CITY OF WESTMINSTER			
PLANNING APPLICATIONS COMMITTEE	Date 19 May 2015	Classification For General Release	
Report of Director of Planning		Wards involved Lancaster Gate	
Subject of Report	104 – 110 Queensway, London, W2 3RR		
Proposal	Use of basement and upper floors of 104 as hotel with ancillary reception at part ground floor with (Class A1) retail use at new mezzanine floor and remainder of ground floor. Erection of mansard storey and rear first and second floor extensions at 104 for hotel use. Use of first and second floors of 110 as two self-contained studio flats (land use swap with 104). Installation of new shopfront to 104. Alterations to existing mansard at 106-110 comprising recladding with natural slate and insertion of lead-clad dormers with timber sash windows. Associated works.		
Agent	Perry + Bell Ltd		
On behalf of	Midas		
Registered Number	15/00494/FULL	TP / PP No	TP/4964/7166
Date of Application	21.01.2015	Date amended/ completed	21.01.2015

1. RECOMMENDATION

104-110 QUEENSWAY, W2

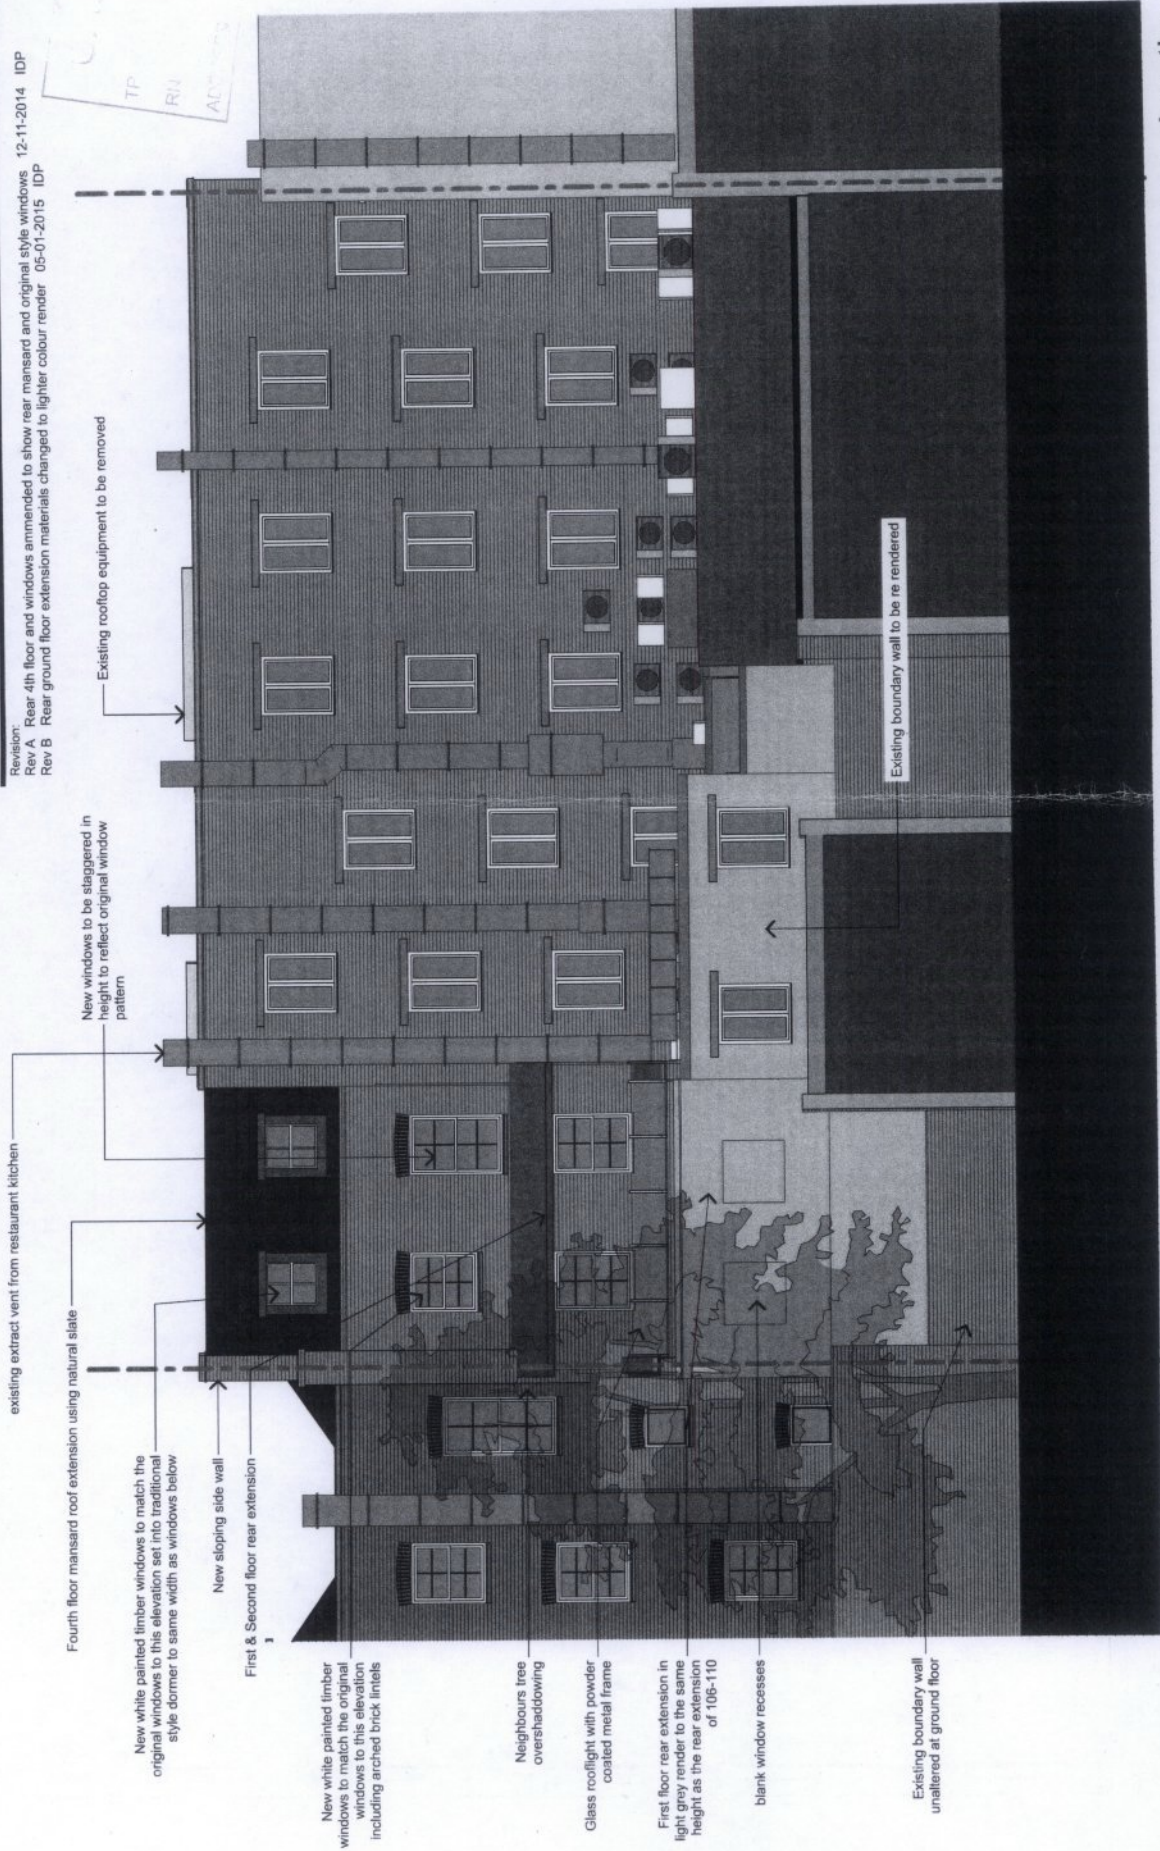
- 9 Notwithstanding the details shown on drawing PL-2.3B, both of the sash windows at second floor level to the rear elevation of no. 104 Queensway and the sash window at third floor level to the south side of the rear elevation of no. 104 Queensway shall be designed as two-over-two sash windows with each sash having a single vertical glazing bar located centrally to each sash and with no horizontal glazing bars to each sash.
